INFORMATION REQUEST
Planning Act 2016 Section 68(1)
Development Assessment Rules Chapter 1 Part 3

Development Application for: Reconfiguring a Lot – Impact – One (1) Lot into Two (2) Lots and Access Easement
Location: 20 Bogong Court and 8 Meharry Court, CABARLAH QLD 4352
Property Description: Lot 39 SP219849 and Lot 37 SP329702
Relevant Planning Scheme: Toowoomba Regional Planning Scheme 2012 (Version 28)

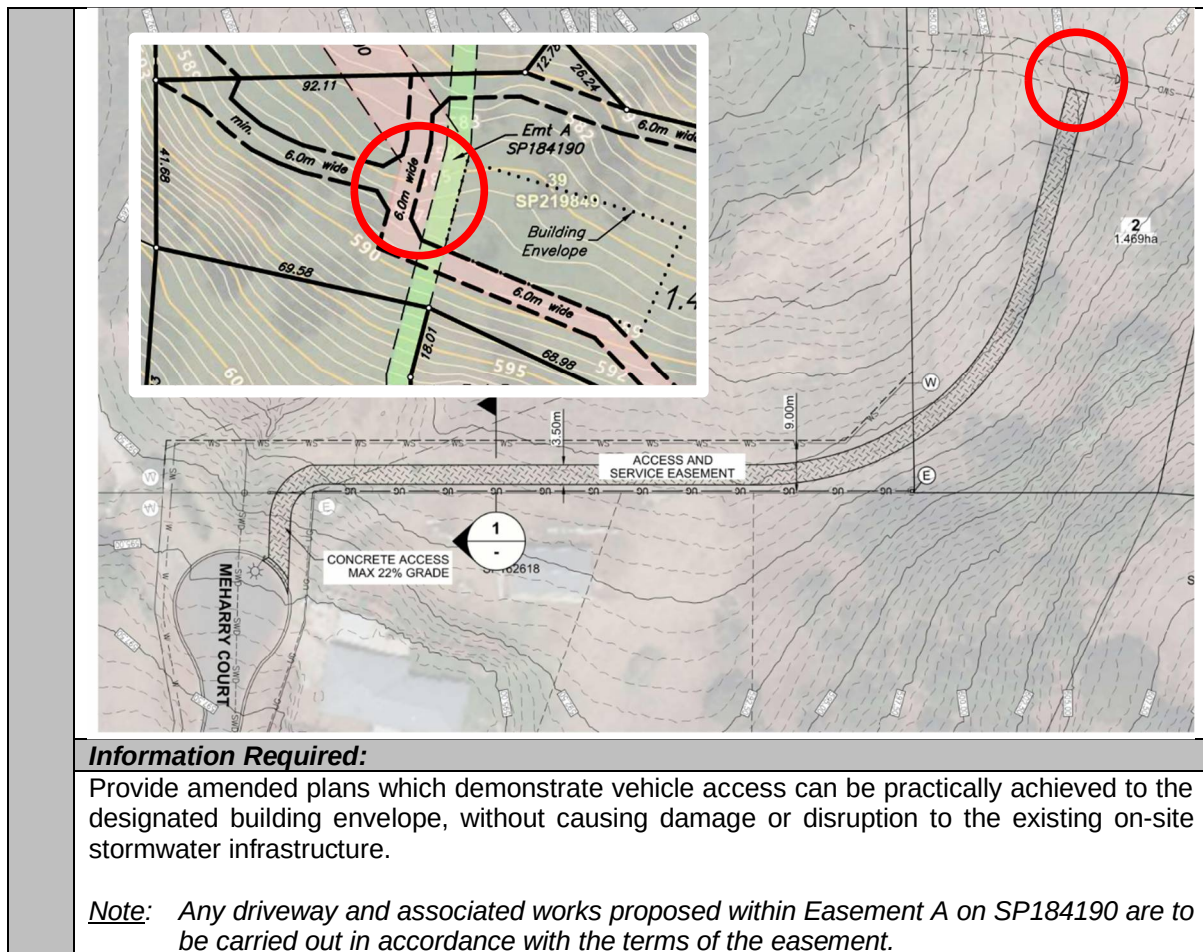
3.1	Issue:
	The proposed development is subject to the wastewater treatment and disposal requirements of the <i>Toowoomba Regional Planning Scheme 2012</i>, as follows: • Performance Outcome PO₄₁ (Table 9.4.5:2) of the Reconfiguring a Lot Code which requires that wastewater treatment and disposal is provided for a development that is efficient, protects amenity and avoids environmental harm; • Performance Outcome PO₁₄ (Table 6.6.6:1) of the Rural Zone Code requires that wastewater treatment and disposal is provided that is appropriate for the level of demand generated, protects public health and avoids environmental harm; and • Performance Outcome PO₄ (Table 9.4.5:1) of the Reconfiguring a Lot Code requires that all new lots provide sufficient area and dimensions that enable their future development to achieve the relevant outcomes in the applicable Zone Code (i.e. provision of on-site wastewater treatment and disposal in accordance with Rural Zone Code). The site is not currently, or planned to be, serviced by a reticulated sewerage system. Therefore, future development will be required to provide for on-site wastewater treatment and disposal.

The information submitted with the development application does not suitably demonstrate that these requirements have been met. In particular, no suitable effluent disposal area has been designated on the proposed plans, and a Conceptual On-Site Wastewater Treatment and Disposal Report has not been provided.
	Information Required: Provide a Conceptual On-Site Wastewater Treatment and Disposal Report prepared by a Suitably Qualified Person demonstrating that a suitable on-site wastewater treatment system can be accommodated on proposed Lot 2. The Conceptual On-Site Wastewater Treatment and Disposal Report must include but not be limited to the following information: • A Site Plan detailing the proposed on-site effluent disposal system and suitable land application area in relation to development/site features (e.g. site boundaries, building envelope, significant vegetation, landslide hazard areas, bushfire covenants, access driveway etc.); • An assessment of the soil type; • Appropriately sized to accommodate a future residential dwelling; and • A conceptual on-site wastewater treatment system design that complies with the requirements of the QPWC and its referenced standards, including the separation distances from boundaries, structures and watercourses.
